SERVICE PROCEDURE

**G-08503
MAY 2008**

SUBJECT: **SAFETY RECALL (U.S.)
**BENDIX MV-3 DASH CONTROL VALVE on certain
4000, 5000, 7000, 8000, 9000, and ProStar models
built 1/15/2008 thru 2/7/2008.****

Figure 1. Bendix MV-3 Dash Control Valve

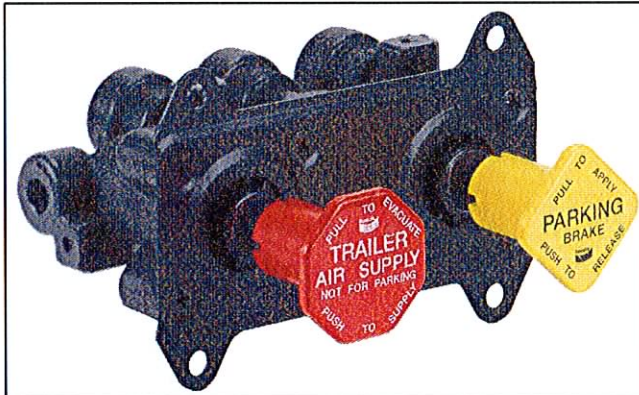
On vehicles equipped with a Bendix MV-3 dash control valve, the rubber double check valve may become lodged in the valve body. In the event of a primary reservoir failure, air pressure may leak past the lodged double check valve thereby depleting the secondary reservoir, causing reduced ability for modulating the service emergency brakes.

1. Park the vehicle on a hard level surface; set the parking brake; turn the engine off; and block the wheels to prevent the vehicle from moving either forward or backward.
2. Locate Bendix MV-3 dash control valve. Valve is shown in Figure 1. Remove dash panel access cover(s) to expose valve body cover plate. Remove valve mounting screws.

3. With air lines still connected, pull the valve through dash panel opening so that the valve body date code may be inspected. Determine if the valve is applicable to the recall using the attached Bendix® MV-3® Dash Control Valve Recall Campaign Identification Guide.

4. If the recall is not applicable to the valve, no further service is required. Reinstall valve and access cover(s) in dash panel.
5. If the recall is applicable to the valve, replace the valve using attached Bendix MV-3 installation instructions. Check for any air leaks. Reinstall access cover(s) in the dash panel.

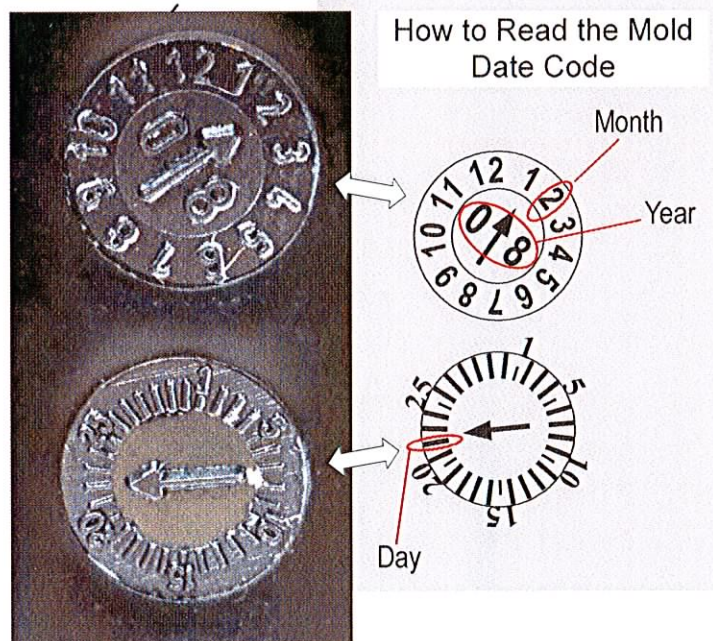
Step 2: Locate the MV-3® valve body **mold** date code located on the side of the valve as shown here. *(Note: only use this mold date when evaluating a valve body. There is also an etched Bendix manufactured date code stamped below the mold date indicator - do not use the etched date to guide you.)*

Step 3: Identify if the **mold** date code falls within the recall date code range from 12/19/2007 through 1/21/2008 inclusive.

Step 5: If the valve is subject to the recall campaign it must be replaced per the recall campaign guidelines.
